COMPANY / PROJECT
ST185 CELICA GT-FOUR - LINK ECU CONVERSION

TITLE
LOGIC BUS STRIP BUS1

PART / DWG NO.	REV	MATERIAL
ST185-FB-115	E	C110 COPPER, TINNED

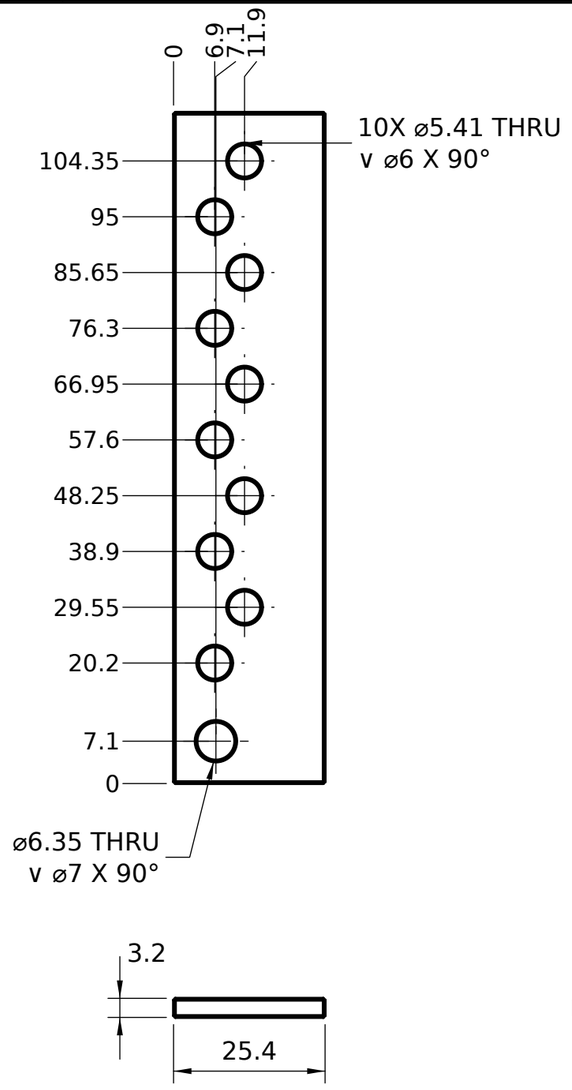
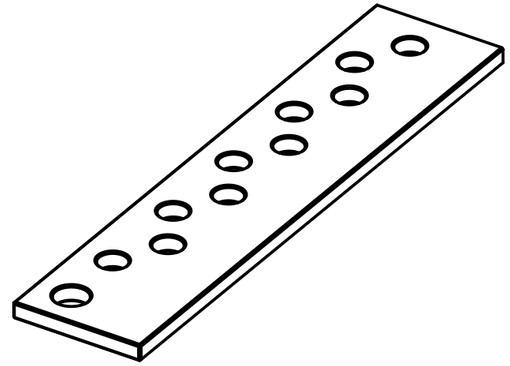
REV	DESCRIPTION	BY	DATE
A	Initial	Claude	14/10/26
B	J1-J4 answers (R94) (#217)	Claude	15/10/26
C	SteveCAD audit v3 fixes ported into the source (#272)	Claude	16/10/26
D	Dan's N2 / N3 / N4 answers (#273); first drawing issued (#280)	Claude; drawing SteveCAD	16/10/26
E	Dan's markup 17/10/26 (23-21): spare studs deleted, the 10 studs respaced to 9.35 (PEM holes moved)	Claude	18/10/26

1. MATERIAL: C110 COPPER, TINNED. CUT FROM 1" x 1/8" (25.4 x 3.2) TINNED FLAT BAR (MECCANIXITY B0CGJC2S1L); ONE 305 BAR MAKES BUS1 + BUS2.
2. HOLES ARE PEM MOUNTING HOLES, NEVER TAPPED (R129): ⌀5.41 +0.08/-0 FOR PEM S-M4-2ZI AT EACH M4 STUD, ⌀6.35 +0.08/-0 FOR PEM SS-M5-2ZI AT THE M5 FEED. PRESS NUTS IN FROM THE STRIP FACE.
3. 0.3 x 45° EDGE BREAK IS MODELLED (THE ⌀6.01 / ⌀6.95 RIMS) - R138 / R76.
4. MOUNTS ON EDGE IN THE LOGIC BASE. DEBURR ALL HOLES AND EDGES.
5. MARKUP 2026-10-17: SPARE STUD POSITIONS DELETED; STUDS ON A 9.35 PITCH (BUS1 10, BUS2 9).
